SUMMARY

Proposal:	Demolition of the existing townhouses and tree removal and the construction of a five (5) storey residential flat building with affordable rental housing component and two (2) levels of basement.
Applicant:	Bechara Chan & Associates
Owner:	A & A Lederer Pty Ltd
Date of lodgement:	1 May 2020
Notification period:	First round: 7 May 2020 to 21 May 2020 Second round: 1 October 2020 to 22 October 2020
Submissions received:	First round: Three (3) submissions received Second round: One (1) submission received
Assessment officer:	ND
Estimated cost of works:	\$11,791,430
Zoning:	R3 Medium Density Residential- SLEP 2012
Heritage:	The site is located opposite heritage item No. I152 – “Manx Cottage”.
Flood affected:	Yes
Is a Clause 4.6 variation proposed?	Yes – Building Height
Extent of the variation supported?	The Clause 4.6 variation is not supported.
Reason for referral to Sydney Eastern City Planning Panel:	CIV of affordable housing component of development exceeds \$5 million

RECOMMENDATION OF OFFICER:	REFUSAL

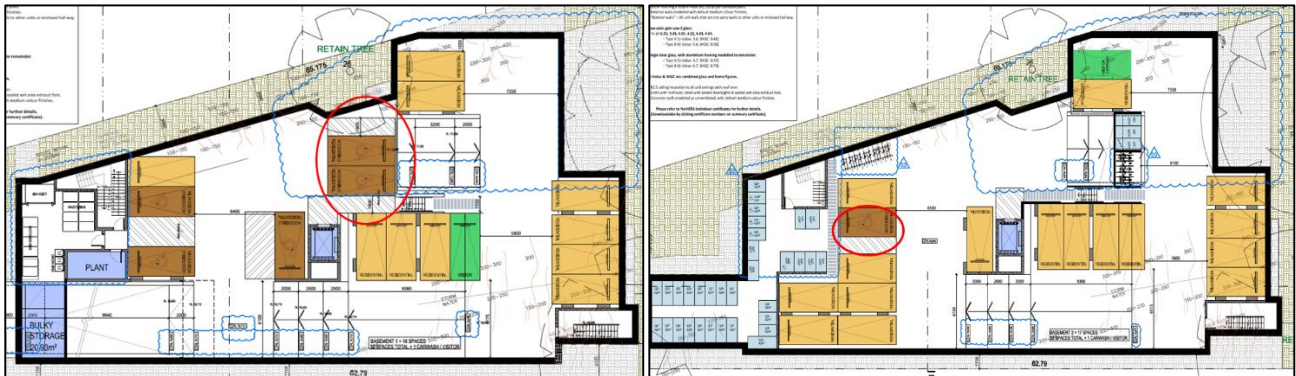
- *"The landscape plan shows the removal of about 25 trees on the site itself, and shows 3 adjacent street trees, one rear neighbour's tree and the planting of only 6 replacement trees (within the site - all small growing species of a maximum 6-8 metres in height)."*
- *The submitted Arborist Report supports the removal of the trees instead of proposing alternatives to the removal of the healthier or larger trees.*
- *It is recommended that this development proposal not be supported and the street trees numbered 1 and 3 and on-site trees 11, 13, 18, 20, 21, 24, 26 and 29 be carefully incorporated into an amended design.*
- *The tree numbered 23 is 1/3 dead and although it is a neighbour's property, its removal would be supportive should such a request be made."*

Figure 7: Height plane of proposed building illustrating building height non-compliance.

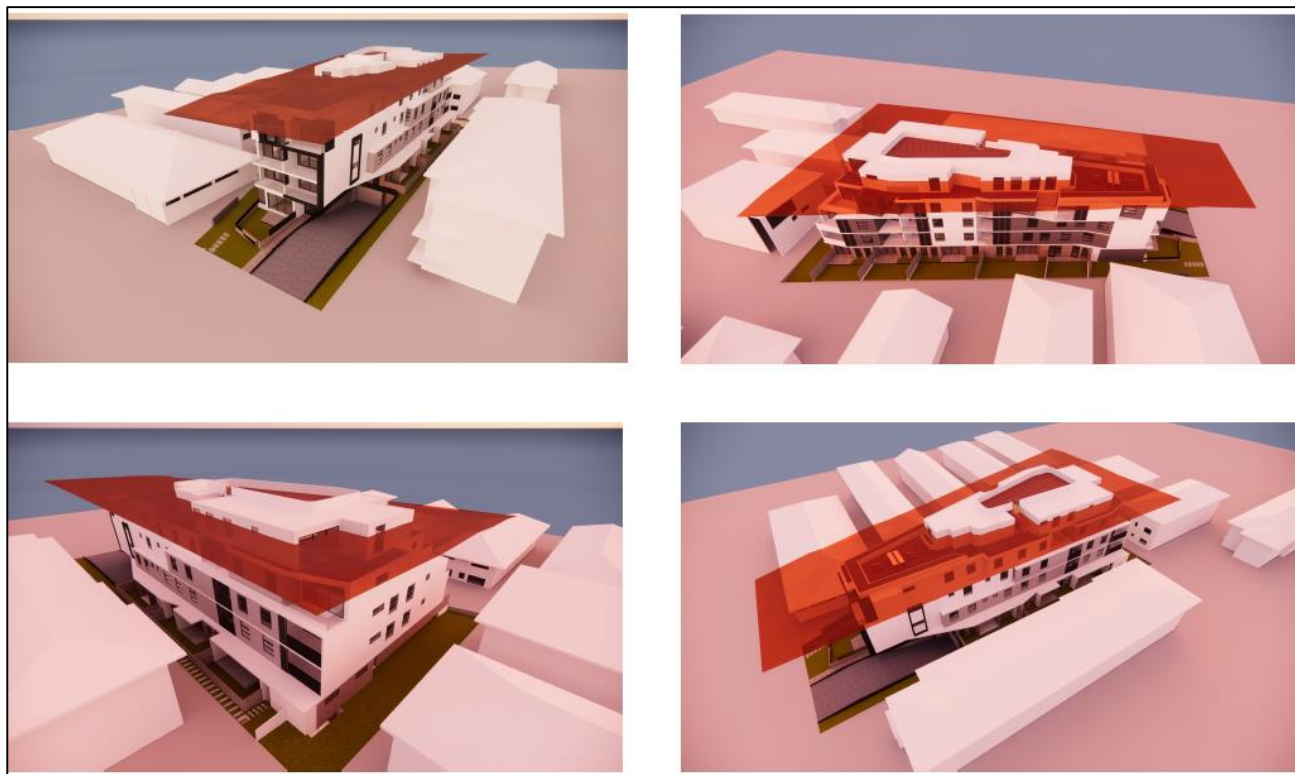
Comments: The proposal will result in a non-compliant 16.13m building height, a 15.2% (2.13m) variation (illustrated in Figure 7). Refer to Clause 4.6 Exception to Development Standards assessment below. The height encroachment facilitates another level of residential living contributing to an overdevelopment of the site.

Figure 1: Sightline diagrams showing the lack of visibility of the upper levels (Source: Bechara Chan & Associates)

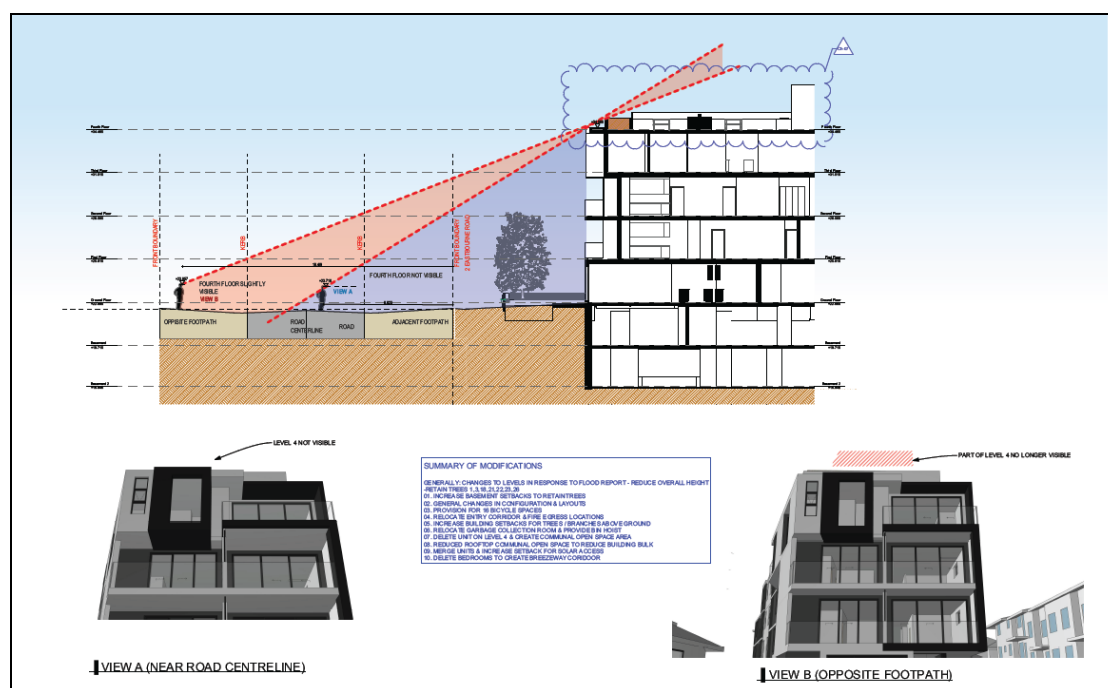
- The submitted plans do not detail a life overrun so the true maximum building height cannot be determined.
- Plans have been submitted demonstrating that the fourth floor and rooftop will not be visible when viewed immediately in front of and opposite the site. The applicant has not demonstrated that the floors will not be visible from adjacent residential streets such as The Crescent, Exeter Road and Hornsey Road.
- The applicant has not demonstrated the extent in which the building has been required to be elevated in response to the flood affectation of the site.
